ROTAX

SERVICE BULLETIN

INSPECTION OR REPLACEMENT OF ENGINE SUSPENSION FRAME PART NO. 886567 ON ROTAX® ENGINE TYPE 912 AND 914 (SERIES)

MANDATORYSB-912-028 R1SB-914-016 R1

see fig. 1

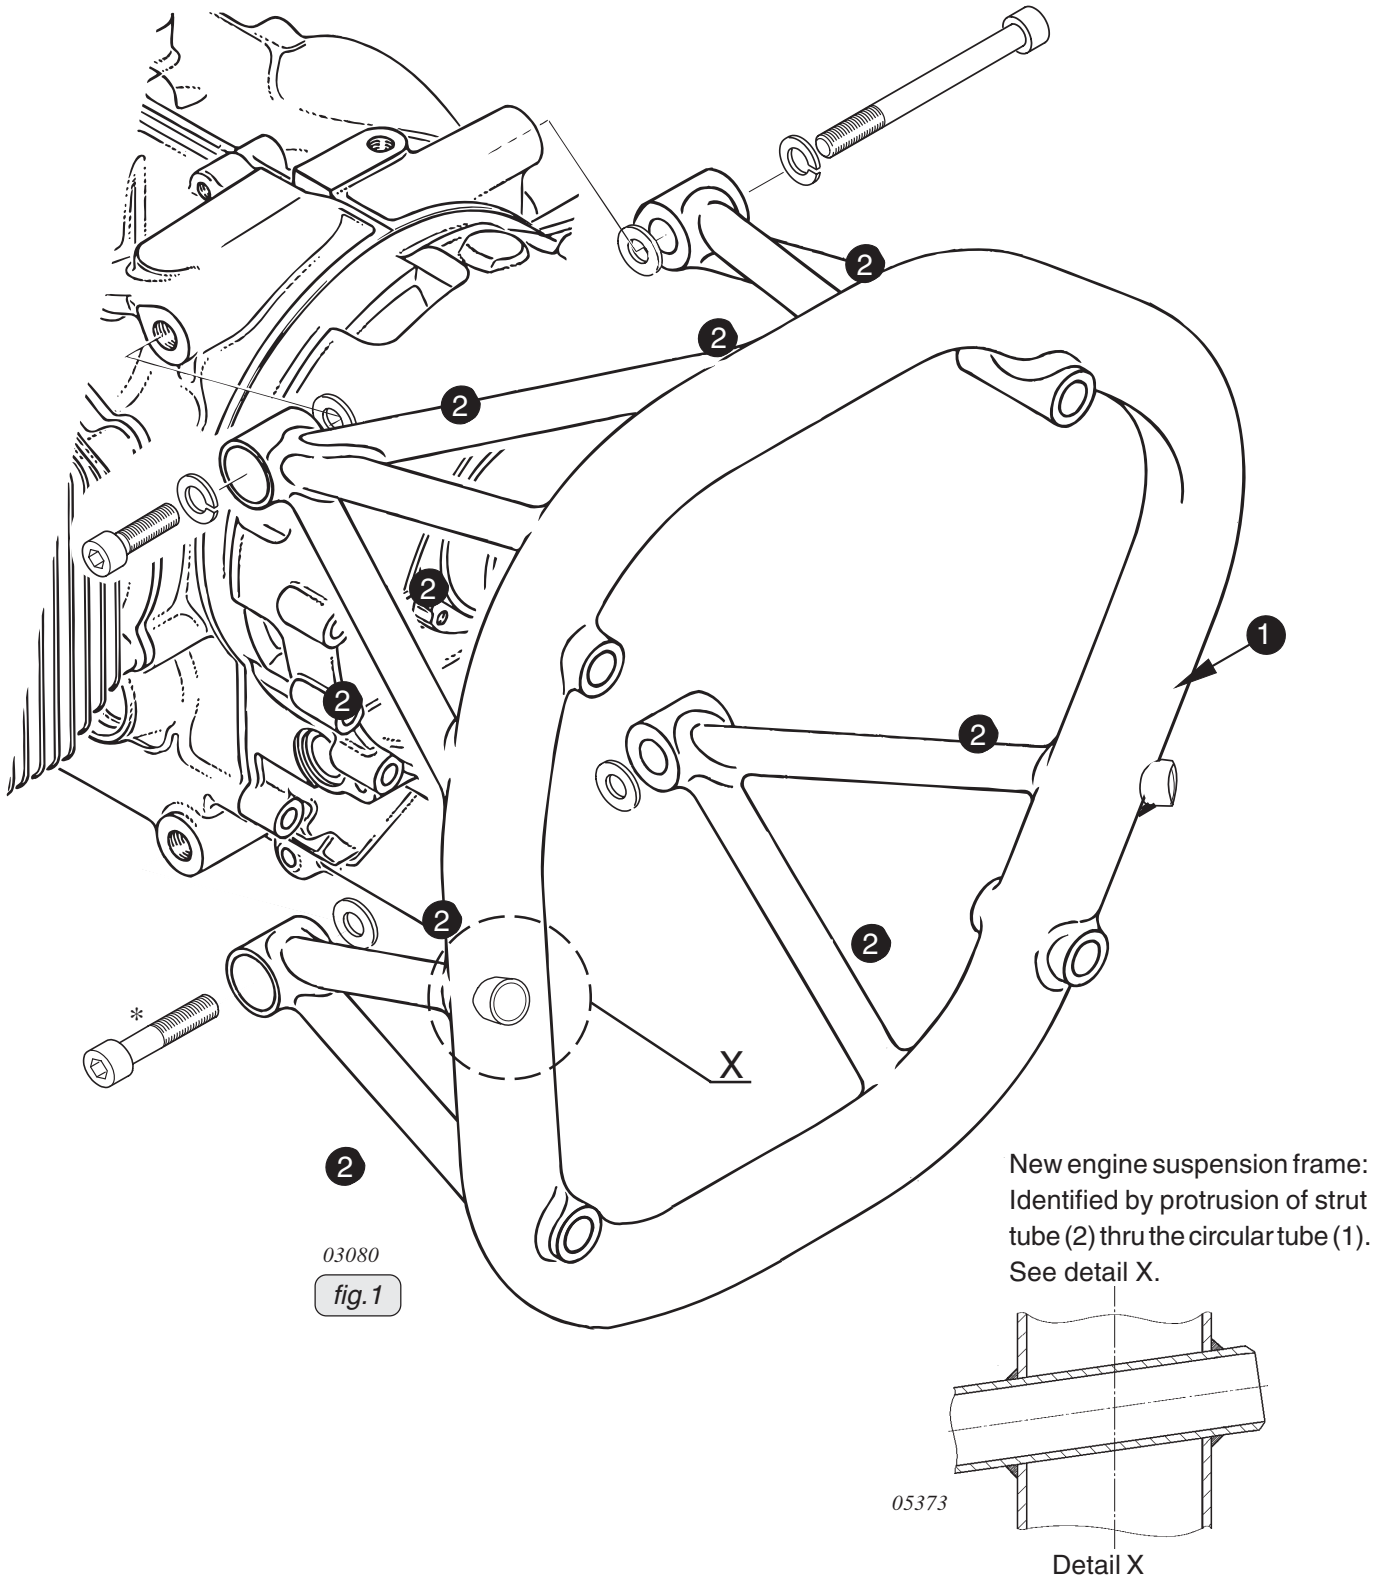
◆ **NOTE:** Inspect the welding connections of circular tubing (1) and the struts (2) of the suspension frame. See fig. 1.

◆ **NOTE:** If absolutely necessary, and if only one of the circular tube or struts are cracked by not more than 50%, a ferry flight is permitted. A complete fracture replacement without delay is necessary.

- If cracks are detected replace the engine suspension frame in accordance to specification of the airframe manufacturer and install the engine suspension frame part no. 886568. This also applies to ROTAX[®] 914 engines in accordance with the relevant Maintenance Manual 914 F.
